CITY PLANNING COMMISSION

APPLICATION: A. Special Permit to develop a parking lot in the Single Family (R-1) and General Commercial (C-2) zones (Section 2-C-31)

PROPOSAL: The applicant is requesting the necessary entitlements to develop a 15 space parking lot on a portion of 0.5+ acres for an existing office and a proposed restaurant use.

APPLC. NO. P87-064 MEETING DATE February 26, 1987 ITEM NO 11

SITE PLAN
1" = 15'

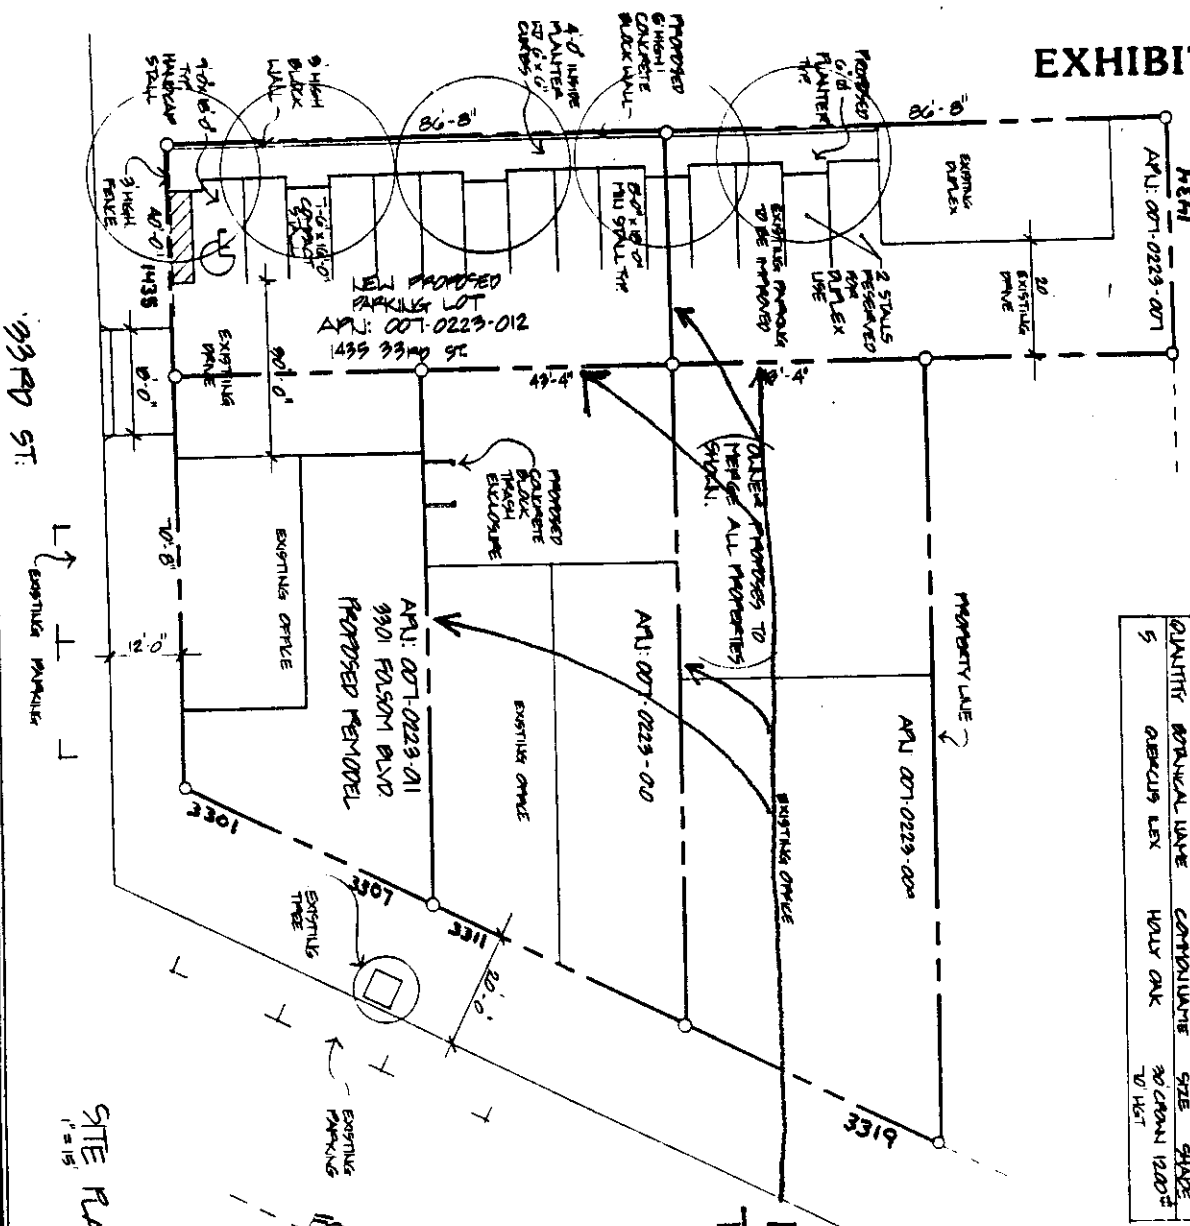
The submitted site plan indicates 15 parking spaces. The proposed parking lot plan has been reviewed by the City Planning, Building and Traffic Engineering Divisions. The following site plan modifications are recommended prior to issuance of building permits:

1. Show the required four-foot-wide planter adjacent to the 33rd Street right-of-way.
2. Eliminate two to three parking spaces and increase planter width to seven feet along the north property line in order to meet 50 percent shading requirement.
3. Indicate existing utility pole in driveway. The pole cannot interfere with parking stall maneuvering. If it does, the pole must be relocated.
4. Indicate existing driveways and existing paving on revised site plan. Driveway entrances are to meet required widths of City Traffic Engineering Division.
5. Existing striped parking on the eastern commercial site shall be indicated on the revised site plan.

1. A revised parking lot site plan shall be submitted for staff review and approval prior to issuance of building permits. The revised site plan shall be drawn to a scale acceptable to the City Building Division and shall indicate the following modifications:

- a. The required minimum four-foot-wide planter with six inch concrete curb (minimum five feet wide, total) adjacent to the 33rd Street right-of-way;

- b. Revised landscape, shading and irrigation plans which meet the City's 50 percent shading requirement and utilize a two-foot planter overhang by parked vehicles;

- c. The existing utility pole in the driveway. The pole cannot interfere with parking stall maneuvering. If it does, the pole must be relocated;
 - d. Existing driveways, existing paving, existing porches, existing walkways and any existing striped parking proposed to remain on the revised site plan. The driveway entrance is to meet required width of the Traffic Engineering Division;

STAFF EXHIBIT
(Not to scale)

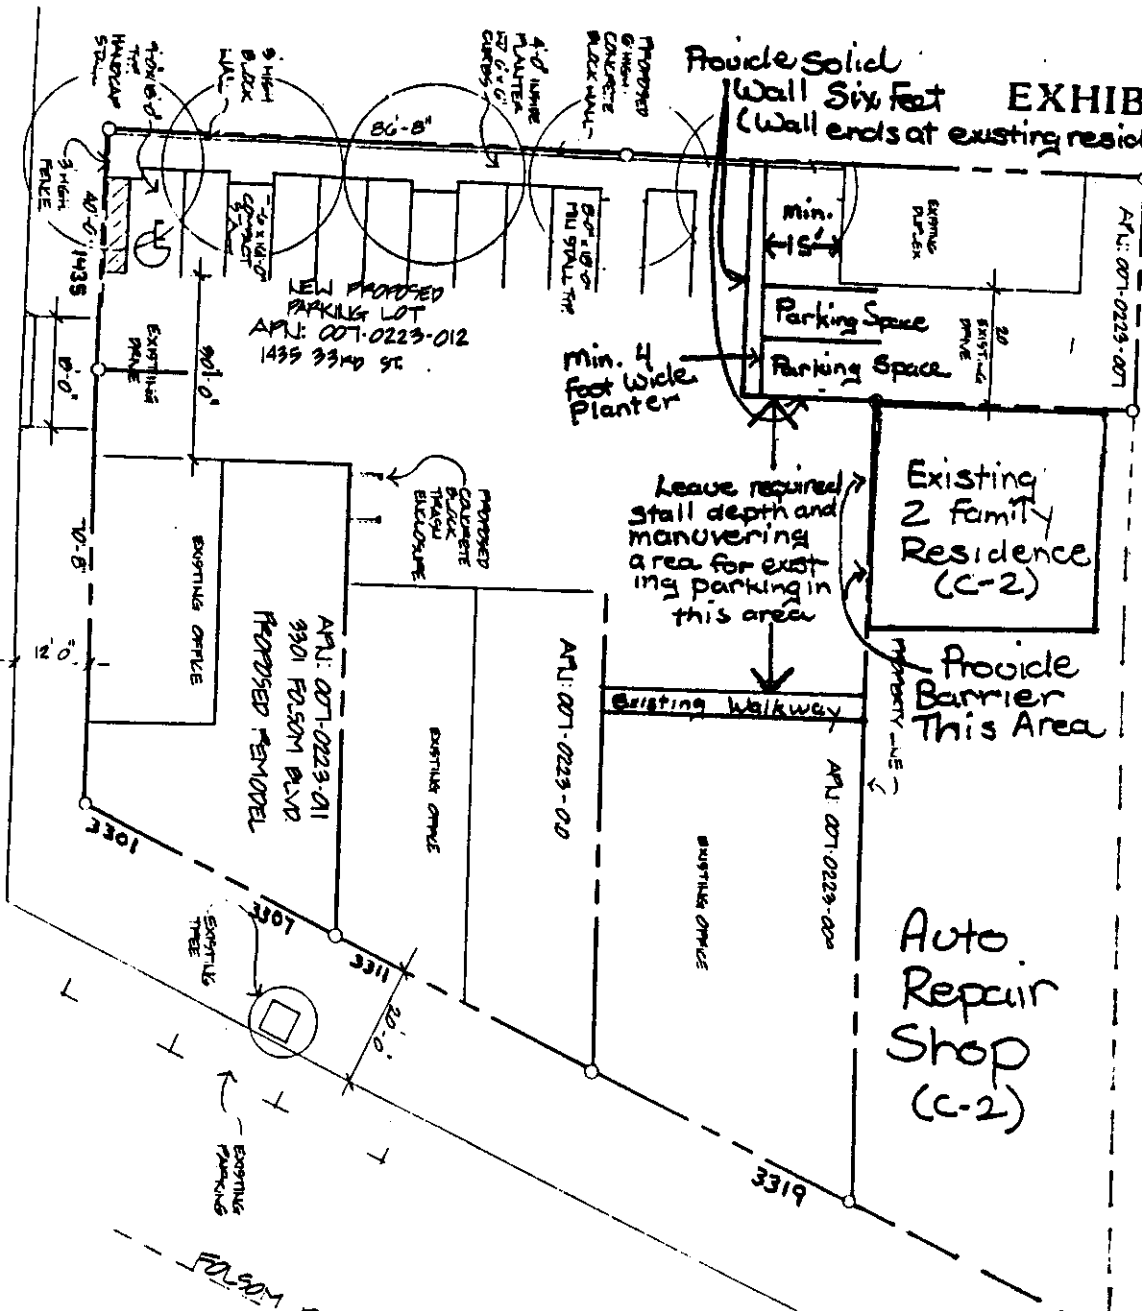
- e. Minimum four foot wide planter adjacent to duplex use as indicated by Exhibit F; and
 - f. Trash enclosure location(s).
2. A six-foot-high solid wall (three feet in front setback area adjacent to 33rd Street) shall be located adjacent to the northern property line and surround the existing duplex as indicated by Exhibit F. Design and materials of the wall shall be subject to Planning Director review and approval prior to issuance of building permits.

4. The applicant shall provide a parking barrier to protect the existing residence on the adjacent C-2 zoned property from vehicles parking on the adjacent site (see Exhibit F). The type of barrier shall be reviewed and approved by the Planning Director prior to issuance of building permits.
